Part number: BC-003144

Chrysler CCD/SCI Scanner		
ChryslerCCDSCIScanner_V144		
2020. 12. 08. 18:06	László Dániel	
Sheet: 1/1	A2	Rev: V1.44

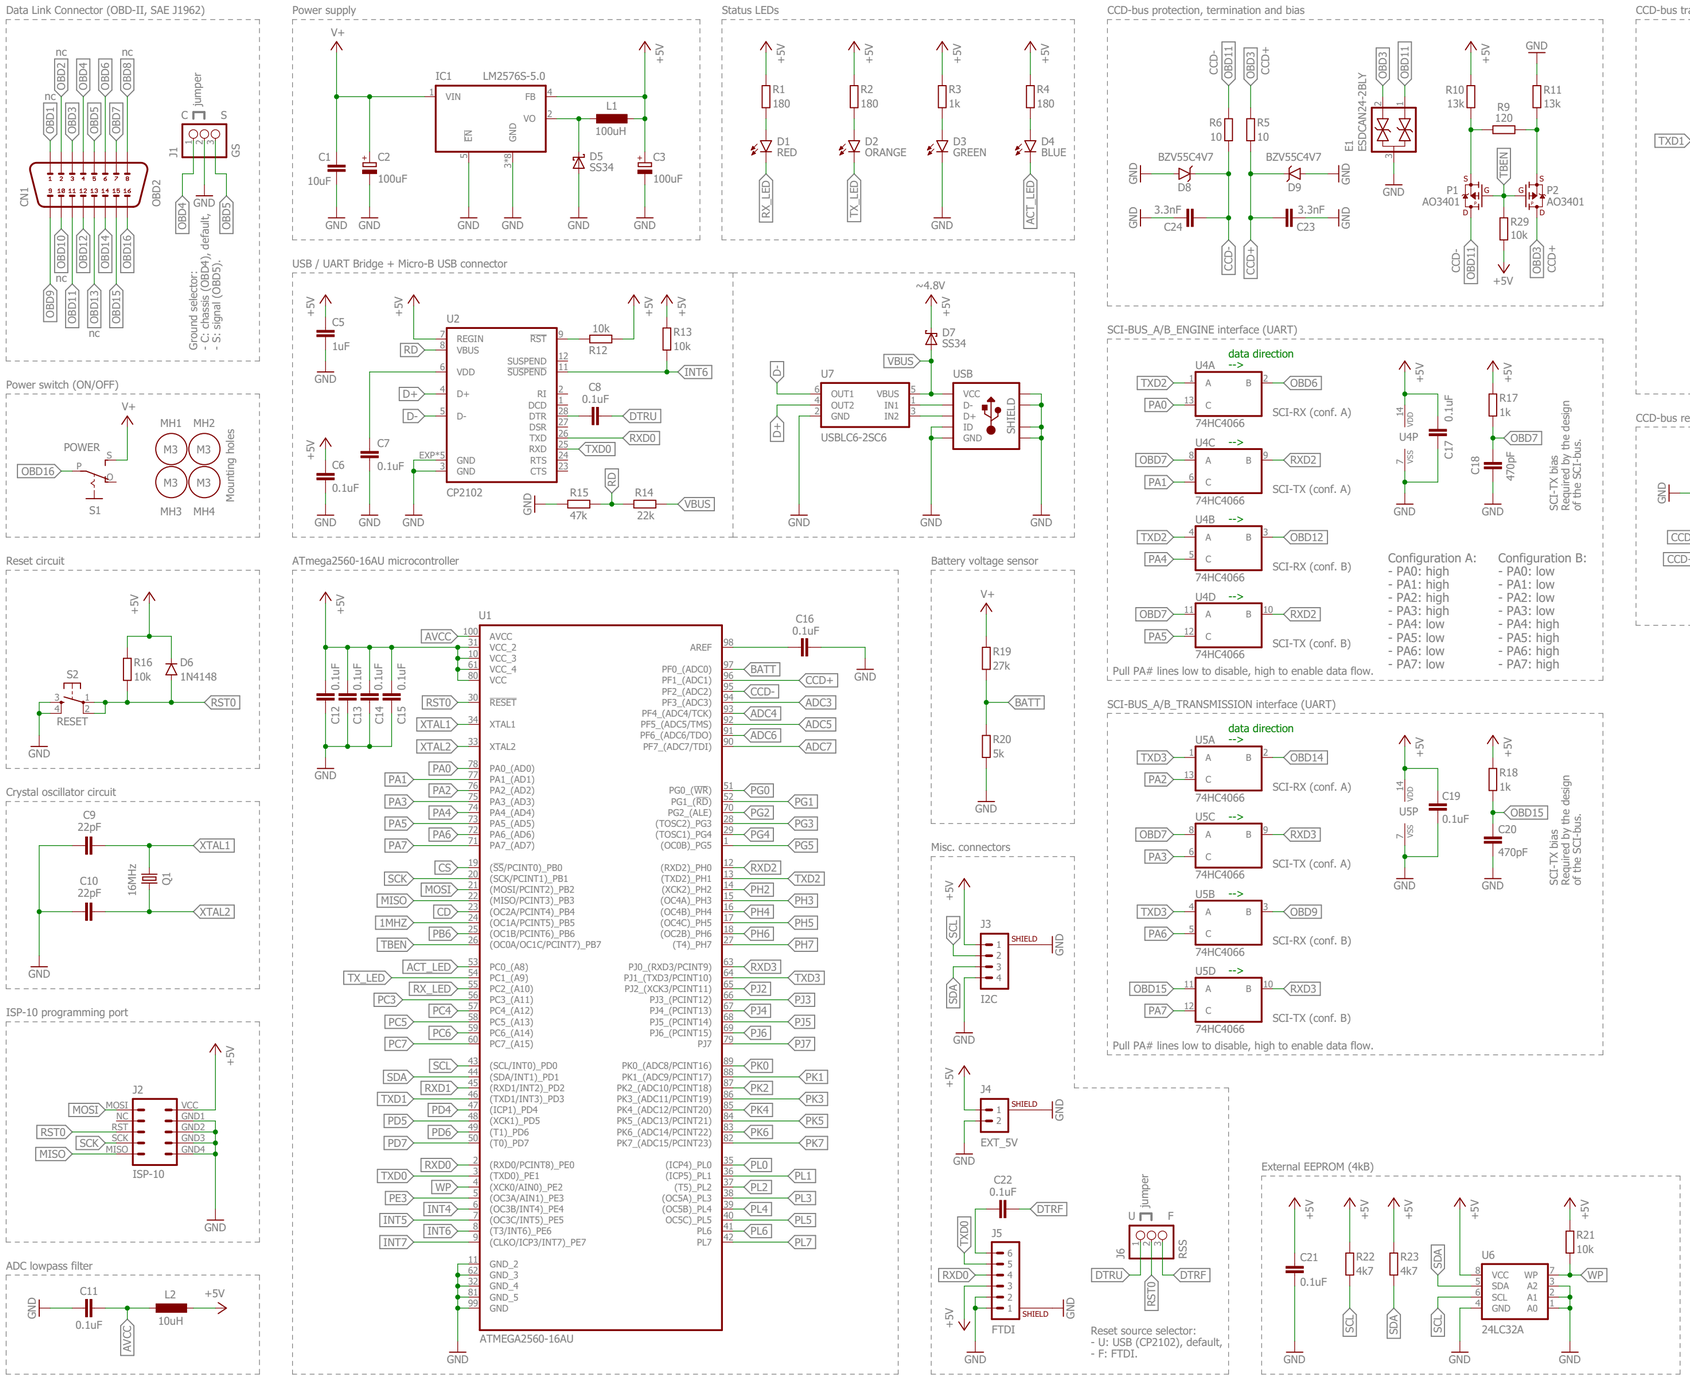
V1.41:
- replace: SMD USB connector with through-hole variant,
- add: FTDI-connector (J7); CP2102 is hard to solder, FTDI programming is a good alternative,
- replace: through-hole C2 and C3 capacitors with SMD-variant,
- components moved around and routing changed to optimize layout.

V1.42:
- replace: J6 (EXT_5V) connector with SMD-variant,
- replace: J7 (FTDI) connector with SMD-variant.

V1.43:
- improve: FTDI/USB (CP2102) programming auto-reset circuit is selectable by the new J8 jumper,
- add: C22 capacitor for FTDI auto-reset, defaults to USB (CP2102) auto-reset,
- add: D8 and D9 Zener-diodes (3.3V) for additional CCD-bus protection against voltage transients.

V1.44:
- improve: CCD-bus transceiver completely re-designed and it no longer uses the CDP68HC68S1E chip; an N/P-channel dual mosfet (U3) and voltage comparator (U8) took its place,
- improve: CCD+ and CCD- pins are routed to analog inputs of the ATmega2560 to measure bus-voltages,
- improve: CCD-bus termination and bias resistor jumpers replaced by P-MOSFET switches (P1, P2) controlled by the ATmega2560,
- replace: D8 and D9 Zener-diode values increased to 4.7V; previous lower value (3.3V) may interfere with the CCD-bus wake-up signal (3.5V minimum),
- add: E1 ESD-protection diode for additional CCD-bus protection.
